1 SITE PLAN SCALE: 1/8"=1'-0"

PROJECT: COSTCO HEAD OFFICE ADDITION

DRAWING TITLE: COSTCO HEAD OFFICE ADDITION

SP-01

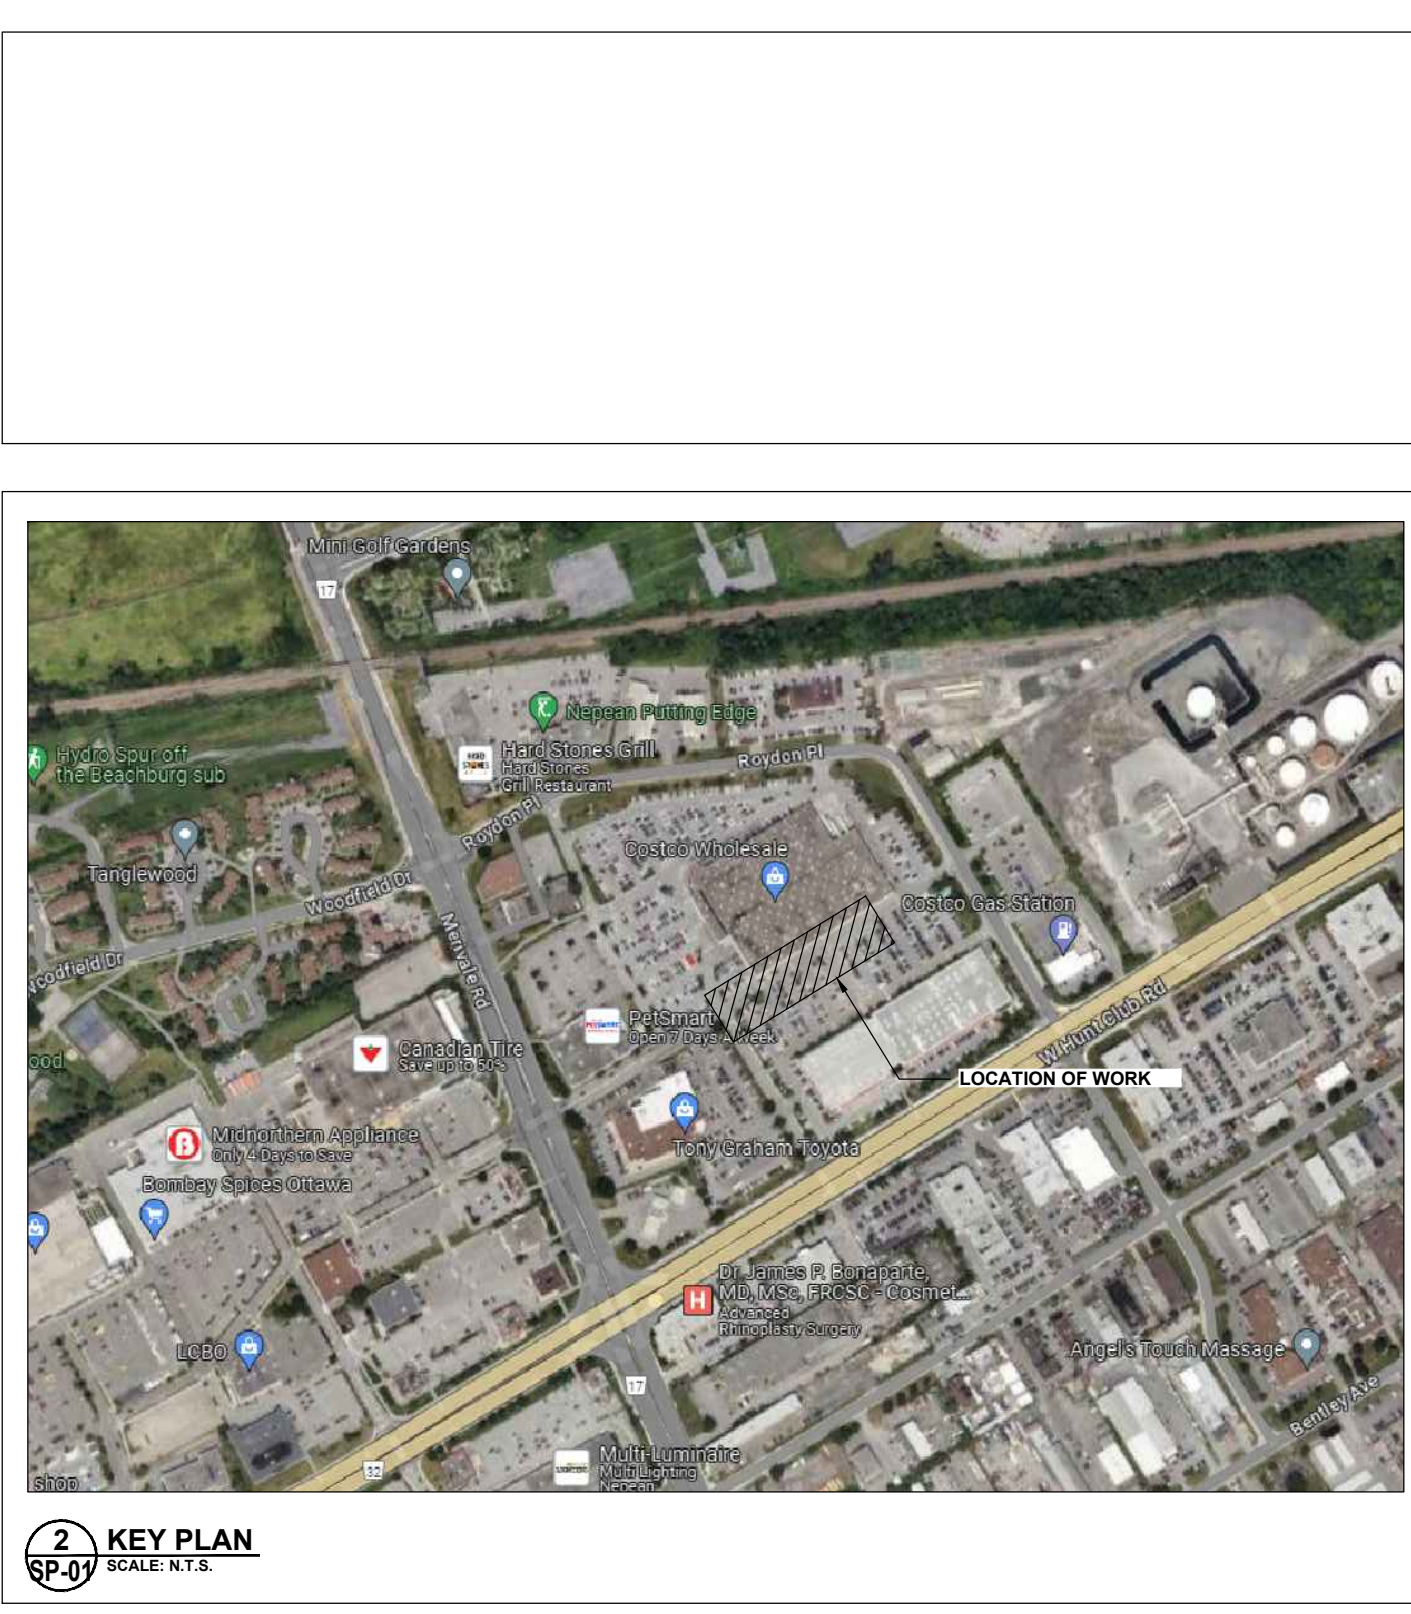
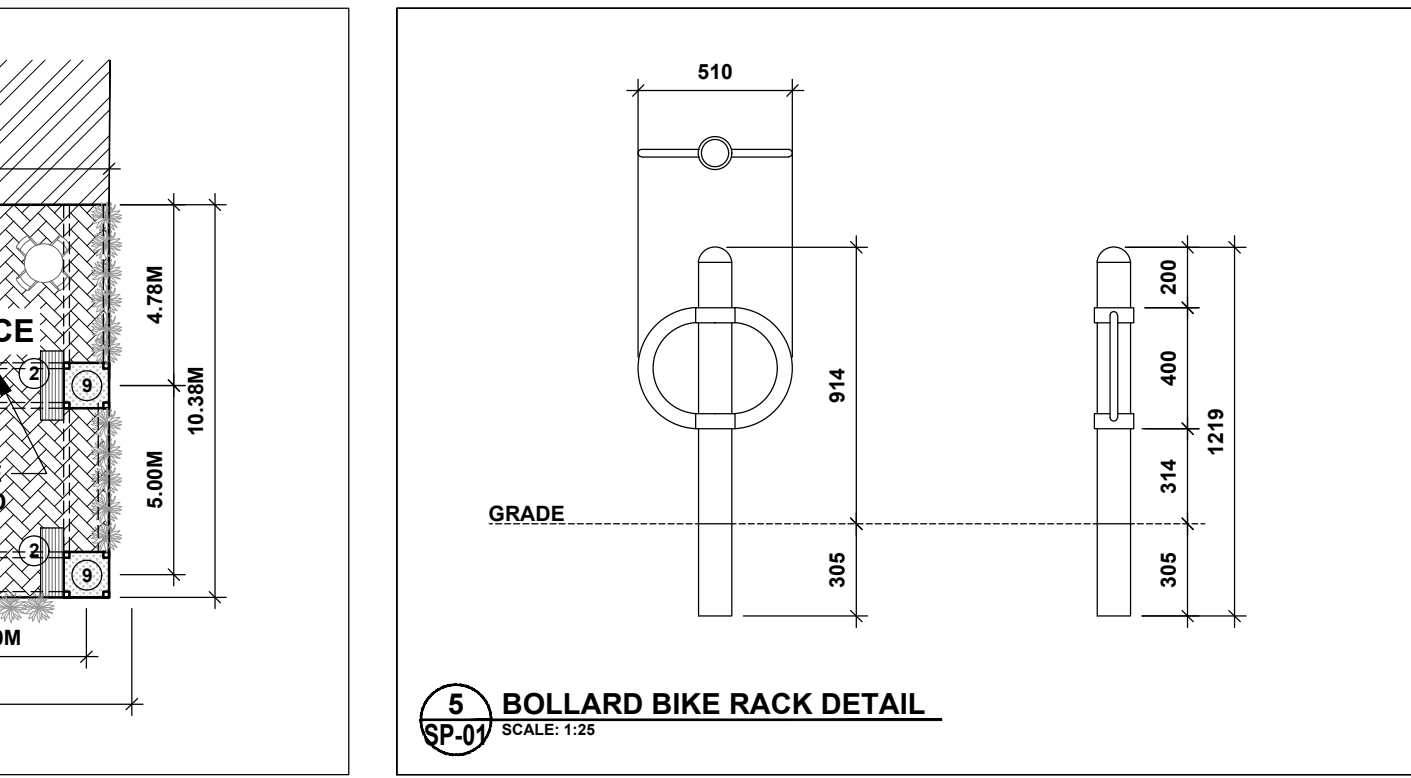
COMMENT: # 7 - IDENTIFY LOCATION OF SNOW STORAGE

RESPONSE: # 7 - SNOW TO BE REMOVED AND STORED OFF-SITE
